# Access Compliance Report

## Public Rights-of-Way

Intersection ID: 44165	Main Street: COCHRANE_DR	Cross Street: FOUNTAINGRASS_LN	Location: NE
ADA ID: 9370C0560443	Ramp Type: PerpDiag	Initial Pass/Fail: Fail	Overall Compliance: No
Severity Score: 18.75			
Codes/Mitigation Info/Possible Solution		Field Measurements/Component Compliance

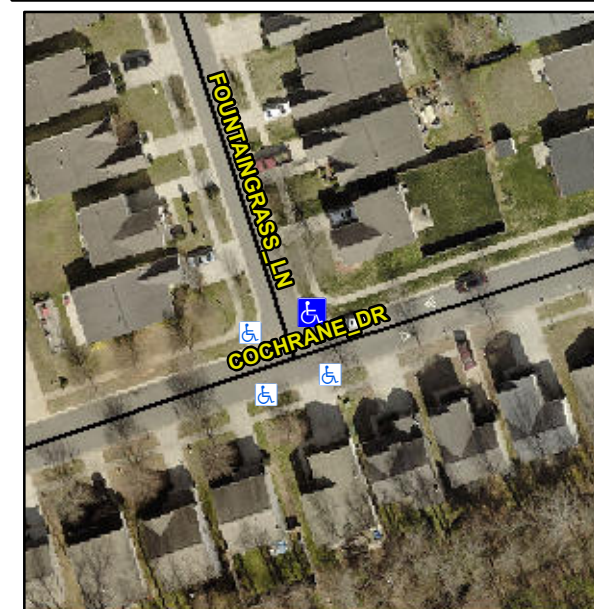
**Not Found, R304.5.1, R304.5.3**

Compliance	Description	Data	Compliance	Description	Data
N/A	Ramp Length (in)	84.5	Yes	Ramp Slope (%)	7.8
No	Ramp Width (in)	34.0	No	Ramp XSlope (%)	3.1
N/A	Flare Type LT	N/A	N/A	Flare Type RT	N/A
N/A	Flare Slope LT (%)	N/A	N/A	Flare Slope RT (%)	N/A
N/A	Flare Traversable LT?	N/A	N/A	Flare Traversable RT?	N/A
N/A	Landing Length (in)	N/A	N/A	DWS Provided?	N/A
N/A	Landing Width (in)	N/A	N/A	DWS Contrast?	N/A
N/A	Landing Slope (%)	N/A	N/A	DWS Length (in)	N/A
N/A	Landing X Slope (%)	N/A	N/A	DWS Full Width?	N/A
N/A	Landing Curb? (Y/N)	N/A	N/A	DWS Offset (in)	N/A
N/A	Shared Landing?	N/A			
N/A	Gutter Ponding?	N/A	N/A	Gutter Slope (%)	N/A
N/A	Gutter Lip Ht (in)	N/A	N/A	Gutter X Slope (%)	N/A
N/A	Painted X Walk1?	No	N/A	Painted X Walk2?	No
	X Walk 1 Direction	To W		X Walk 2 Direction	To S
N/A	X Walk 1 Width (in)	N/A	N/A	X Walk 2 Width (in)	N/A
	X Walk 1 Slope (%)	4.4		X Walk 2 Slope (%)	0.2
	X Walk 1 X Slope (%)	0.5		X Walk 2 X Slope (%)	3.3

**Remove & Replace Curb Ramp With Two New Directional Ramps or Equivalent.**
